ENGINEERING BULLETIN

No: EB/20-21/004,
Date: 10th January 2021

Product Release

New program update
for Model –

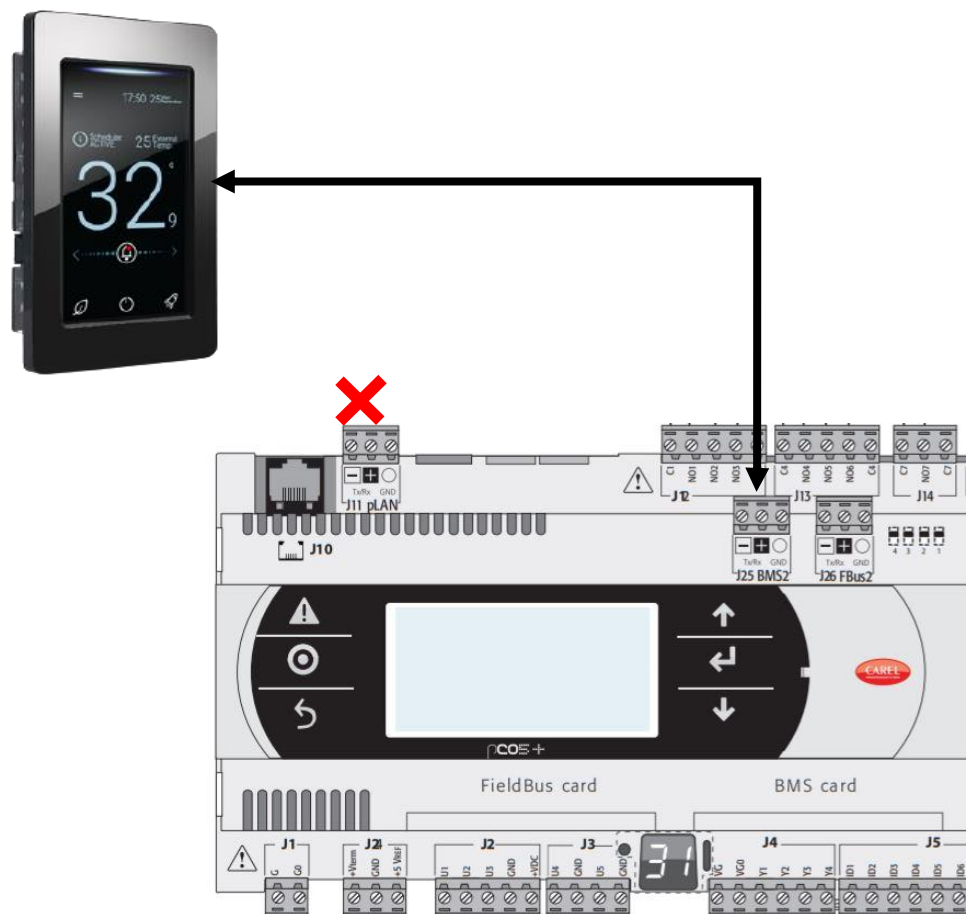
In previous version we had observed communication issue over J11 pLAN port, the response of the touch screen is slower. As a corrective measure we have shifted the screen communication on BMS-2 (J25) port.

Modbus port as per shown in below fig...

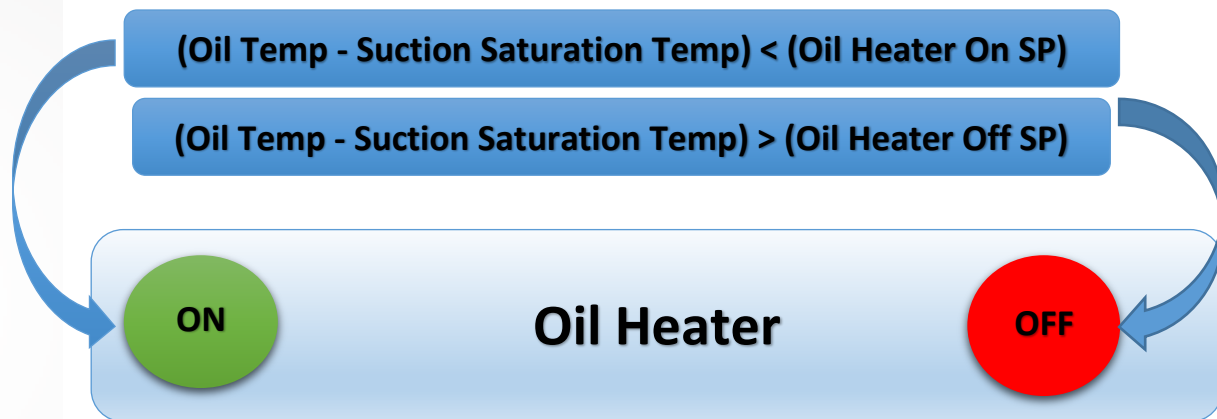
We have made some modification in oil heater logic.
Please refer the below explanation...

Oil heater on/off setpoint available on SUPV Temp
setpoint page as per shown in fig...

In this version oil heater operates as per below flow chart

Oil Heater only work when chiller/compressor is not
running.
